ADDENDUM

Project: Craft State Office Building 1 HVAC
– 200 South Silber Avenue, North
Platte, NE, 69101

Project No.: 23059

Addendum No.: 1

SECOND AND THIRD
FLOOR PLAN -
ELECTRICAL

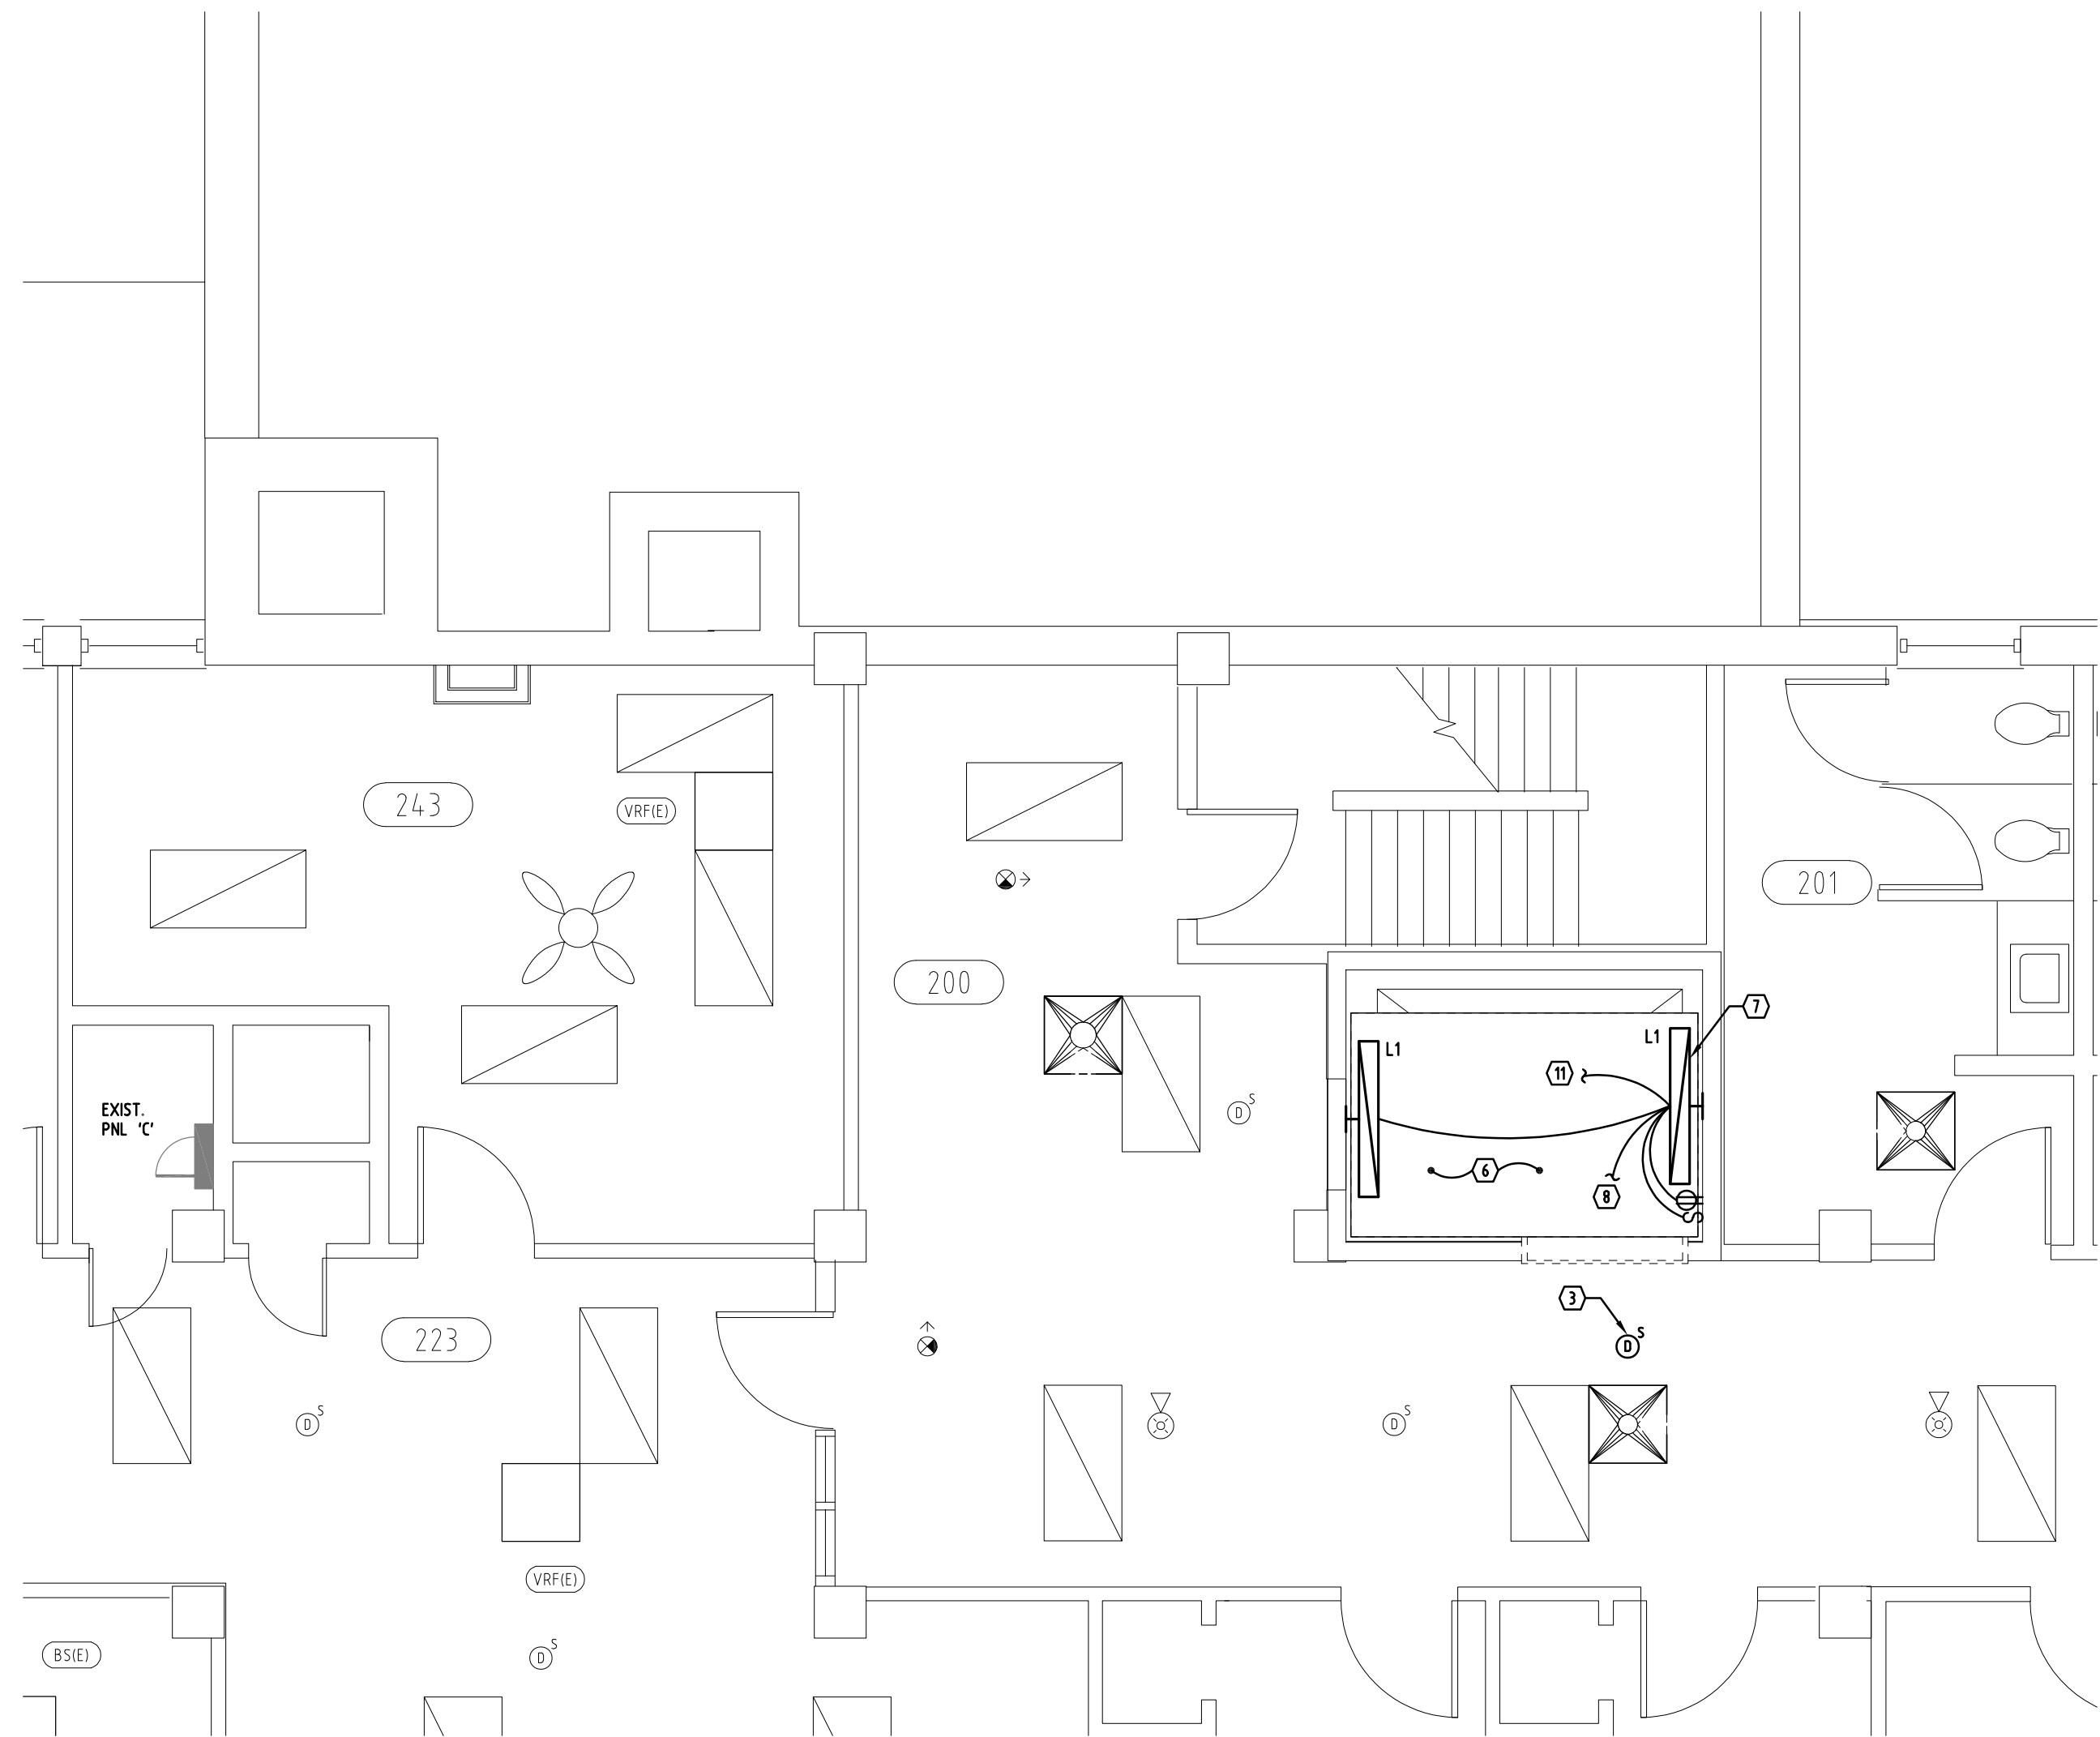
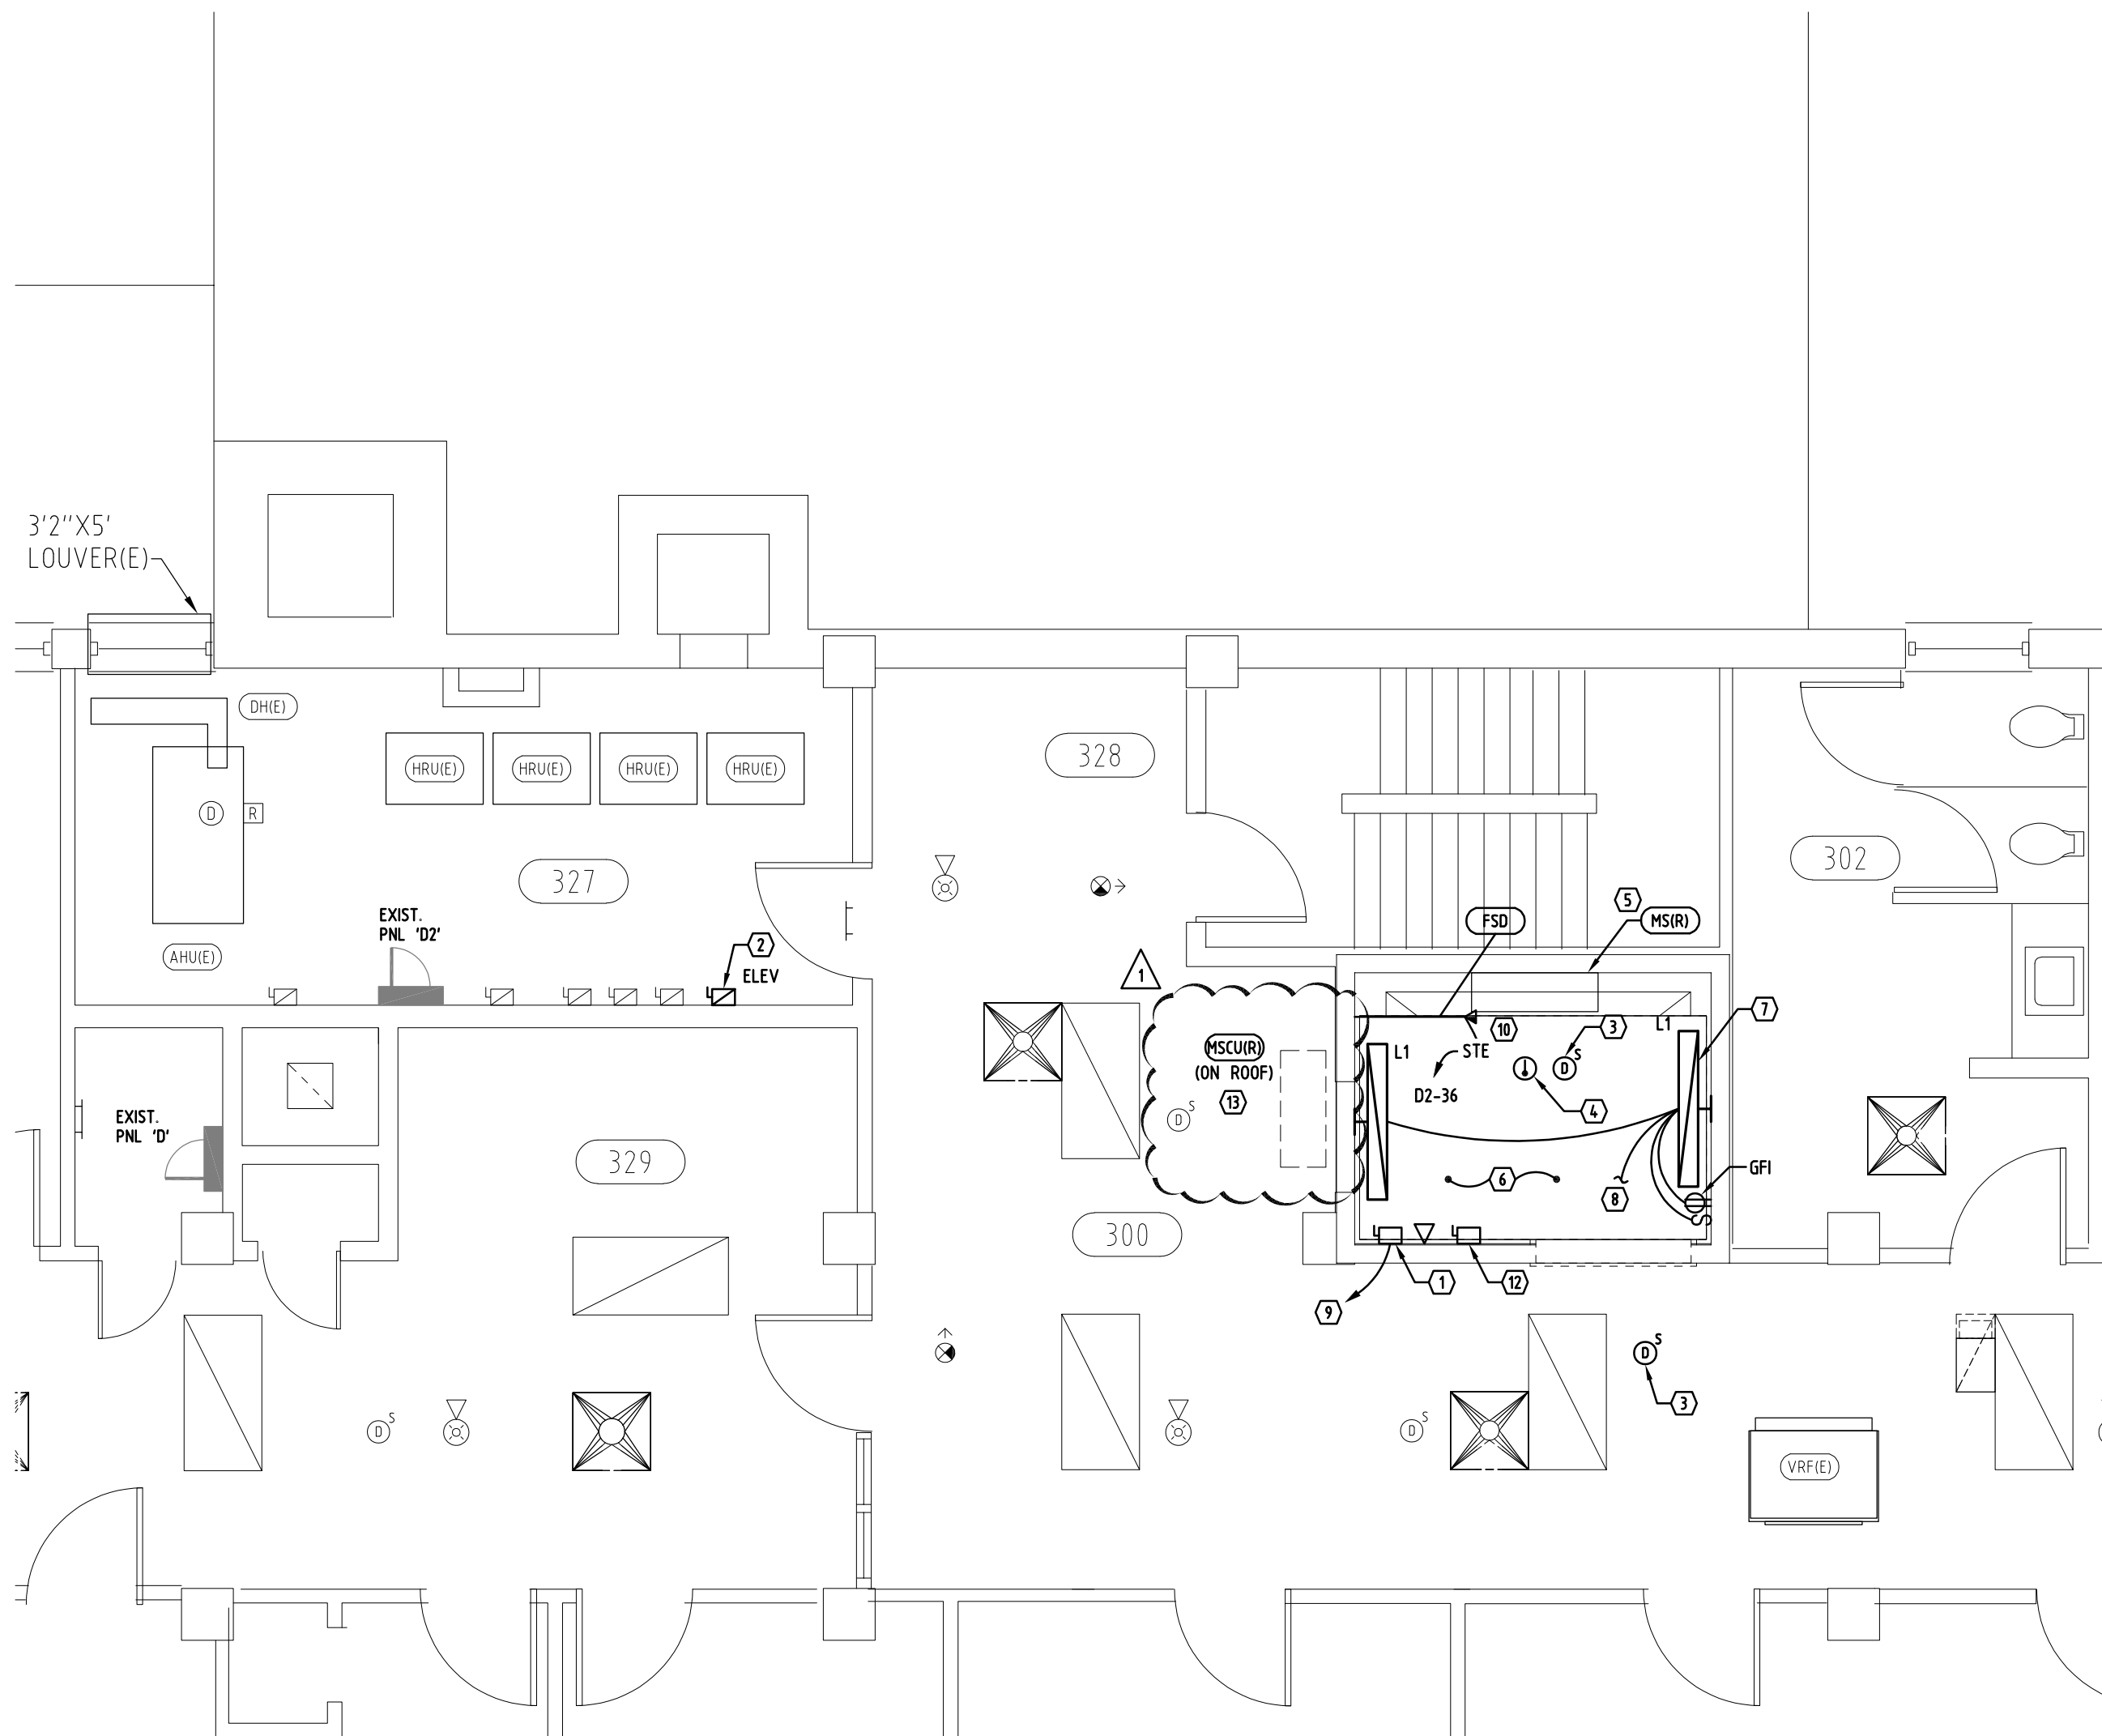
1. **E1.1 – GROUND & FIRST FLOOR PLAN – ELECTRICAL**
 - a. Keynote #12 has been added to specify relocating existing MSCU.
2. **E1.2 – SECOND AND THIRD FLOOR PLAN – ELECTRICAL**
 - a. Keynote #13 has been added to specify the new location of existing MSCU.

13. RELOCATED EXISTING CONDENSING UNIT ON ROOF. ROUTE MATCHING CONDUIT/WIRE TO PANEL 'D2'. PROVIDE NEW MATCHING BREAKER. COORDINATE WITH MECHANICAL CONTRACTOR.
